LiDAR Quality Assurance (QA) Final Report
Sub-project 1: Platte River Corridor
Nebraska/Kansas LiDAR
January 13, 2010

Submitted to:
USDA-NRCS-Nebraska/
U.S. Army Corps of Engineers

Prepared by:
 **Dewberry**
Fairfax, VA

Figure 8: tile 14T NL 7504-2 with a building in the ground classification

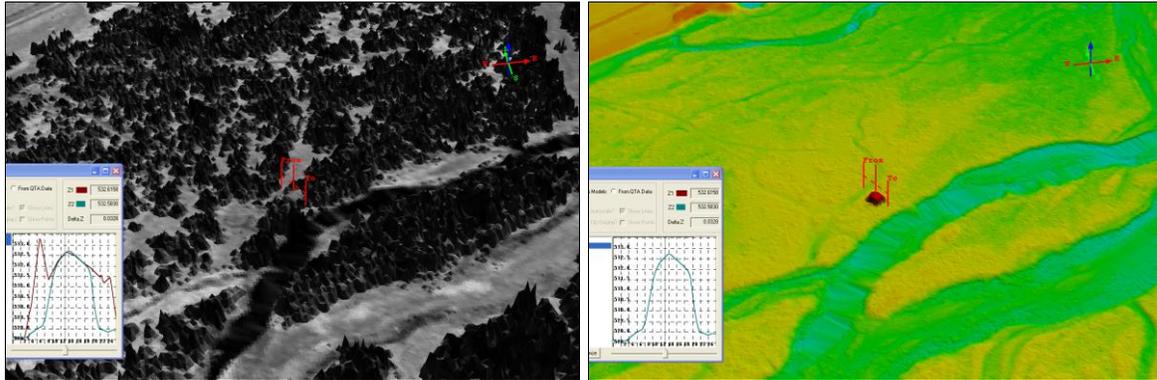
While reviewing the dataset, several buildings were found classified as ground. There is a 2% allowance for building artifacts; therefore these errors do not need to be reprocessed. Figure 8 shows the building remaining in the ground classification. The image on the left shows the full point cloud colored by intensity and the model on the right shows the ground classification colored by elevation. The profile graph shows the full point cloud in red and ground in blue. Please refer to Appendix A for screenshot thumbnails.

Figure 9: tile 14T ML 4005-1 with vegetation in the ground classification

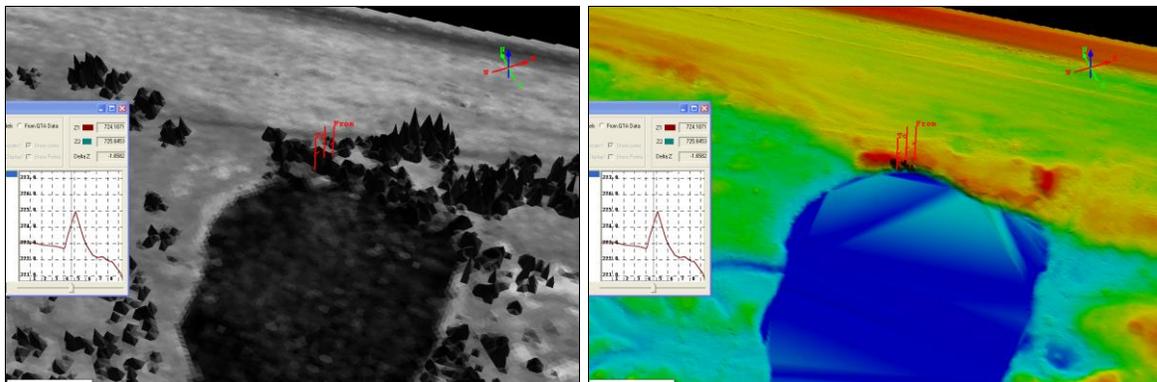
Dewberry also identified one case of vegetation remaining in the ground classification. There is a 5% allowance for vegetation in the project area so this error does not need to be reprocessed. Figure 9 shows the full point cloud colored by intensity on the left and the ground classification colored by elevation on the right. The profile graph shows the height of the artifact in the ground model.

Figure 10: tile 14T LL 1060-4 (left) and tile 14T NL 5015-1 showing small ridges

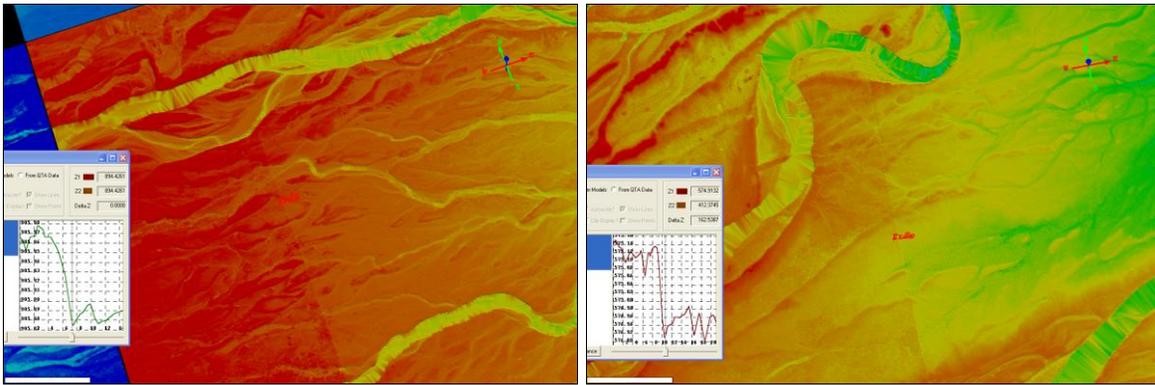
Dewberry identified two ridges in the LAS data. The first, in tile 14T LL 1060-4, does not seem to be caused by collection anomalies such as flight line mismatch, point bunching or spreading, etc. The second, in tile 14T NL 5015-1, follows a flight line seam and probably the result of the slight elevation error along the edge of the collection swath. The ridges are relatively small in height and should not present any major issues with quality or accuracy. In Figure 10 the image on the left shows a ridge in the ground classification that is approximately 6cm high and the image on the right shows a ridge that is approximately 14cm high. Please refer to Appendix A for screenshot thumbnails.

Figure 11: tile 14T ML 1025-3 with noise in the flight line overlap area

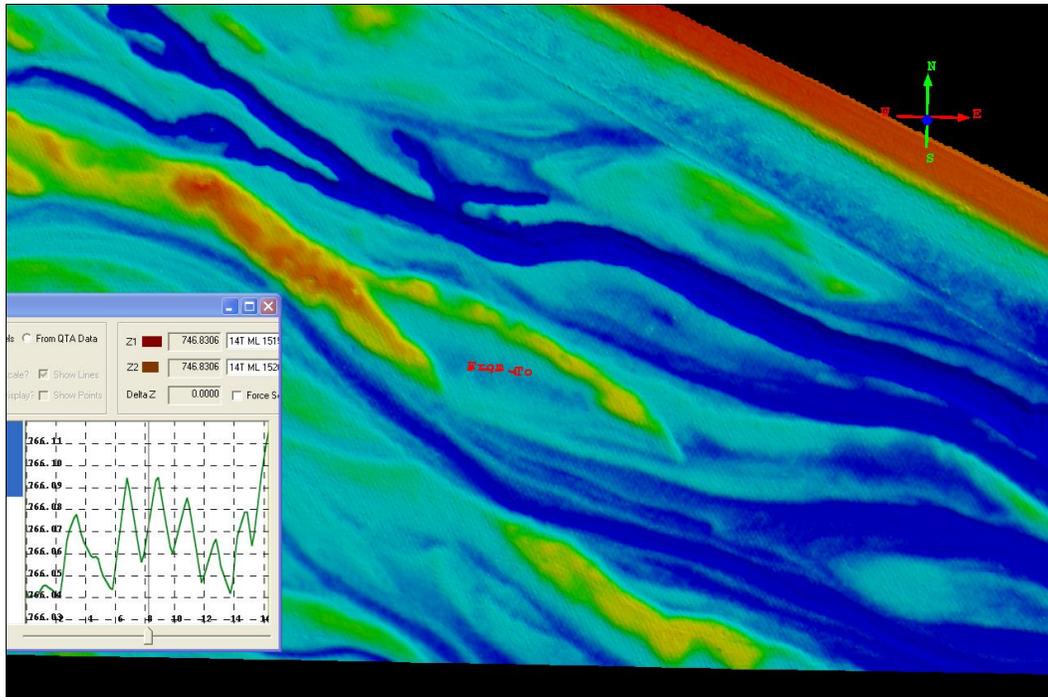
Noise due to small elevation differences between flight lines is a minor error found throughout the dataset. In areas where two or more flight lines overlap, the ground model appears more rough (noisy) as illustrated in Figure 11. All the noisy areas had elevation differences between flight lines of less than 10cm, which is relatively minor and should not affect the usability of the data. Please refer to Appendix A for screenshot thumbnails.

Figure 13: Terrain created with breaklines (with elevation errors)

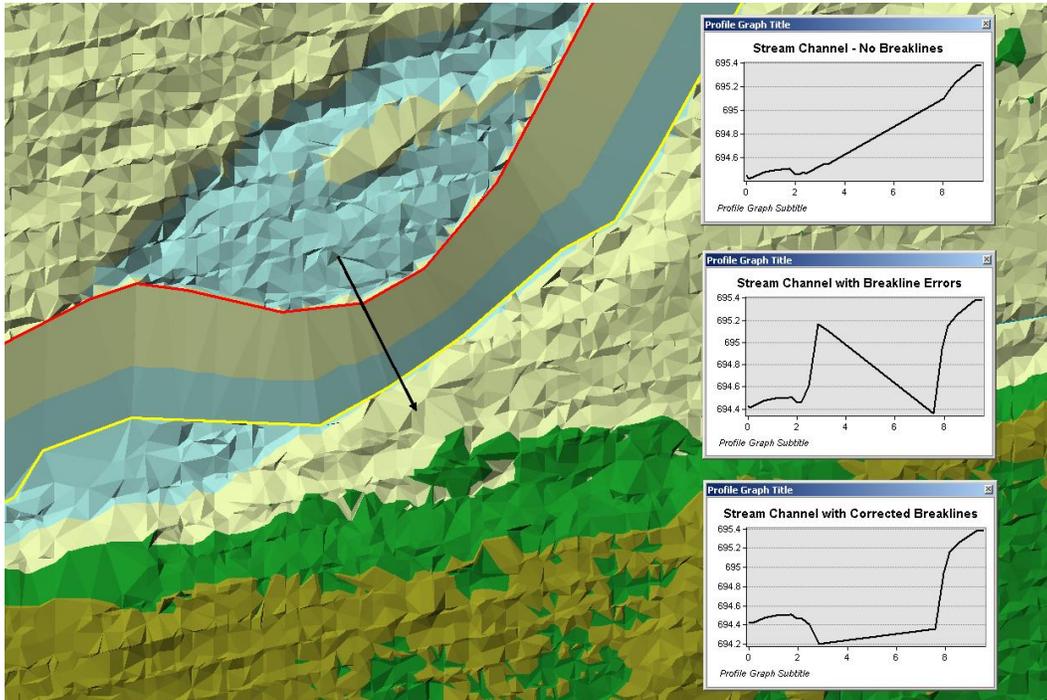
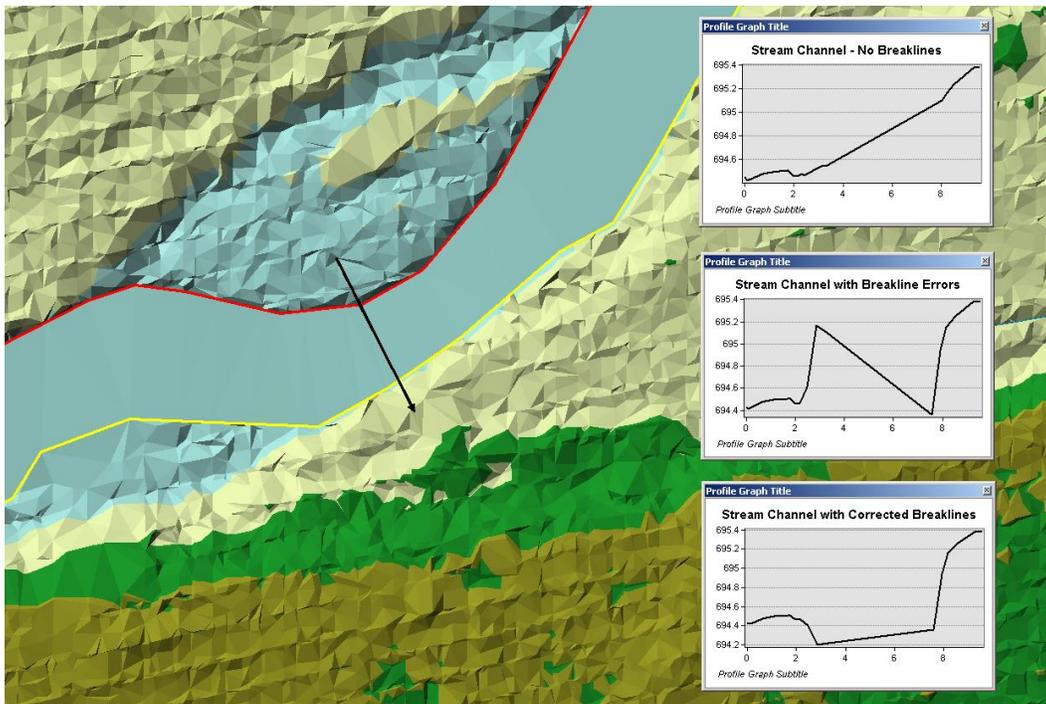
Figure 13 shows a terrain created with the LiDAR ground points and the breaklines. Note how the channel geometry changed due to the influence of the breakline vertex elevations. In the profile graph (middle right), the breakline on the northern bank (left side of the graph) has elevations that are much higher than the LiDAR. This causes the edge of the stream to be

almost a meter higher than the surrounding land, which is unsuitable for hydro modeling. On the southern bank (right side of the profile graph), the breakline elevations are slightly lower than the surrounding LiDAR, causing a trench-like effect. This error is still not desirable, but will cause less of a problem than the “floating” breakline.

The final example in Figure 14 shows a terrain created with the breaklines after Merrick corrected several of the most pronounced vertex elevation errors. The profile graph shows a well defined stream channel where the breakline is the lowest point on each side of the stream. While there still are small elevation differences between the LiDAR and the breaklines, this provides the best model of the land surface for hydro modeling.
